3.5L GTDI—INTERMITTENT STUMBLE/MISFIRE ON ACCELERATION FROM HIGHWAY CRUISE IN HUMID OR DAMP CONDITIONS WITH POSSIBLE DTC

TSB 12-10-19

2011-2012 F-150

This article supersedes TSB 12-6-4 to remove the the production fix date, update the Title, Issue Statement, Part List and Service Procedure.

Figure 1 - Article 12-10-19

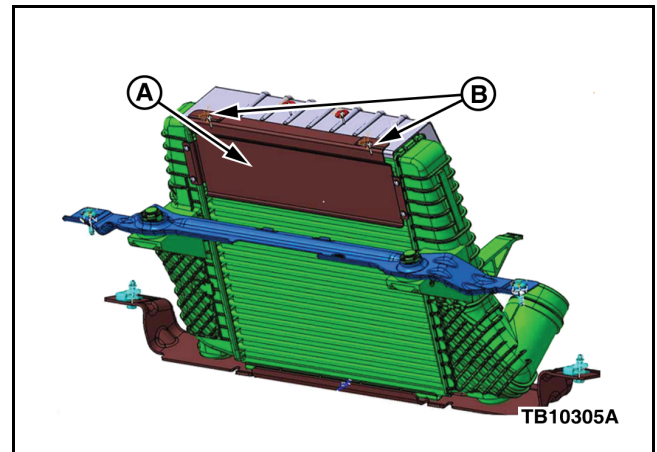
1. Check for DTC P0430. Is DTC P0430 present?
 - a. Yes - Replace the left bank catalytic converter assembly. Refer to Workshop Manual (WSM), Section 309-00. Proceed to Step 2.
 - b. No - Proceed to Step 2.
2. Is the Charge Air Cooler (CAC) equipped with an air deflector plate? (Figure 1A)

- a. Yes - Proceed to Step 5.
 - b. No - Proceed to Step 3.
3. Install a new CAC, new air deflector plate, and original shield using new retaining pushpins. Refer to WSM, Section 303-12. (Figure 1B) Proceed to Step 4.
4. Reprogram the PCM to the latest calibration using IDS release 79.02A or higher. This new calibration is not included in the 2012.5 DVD. Calibration files may also be obtained at www.motorcraft.com.
5. Install a new CAC and the original air deflector plate and shield using new retaining pushpins. Refer WSM, Section 303-12.
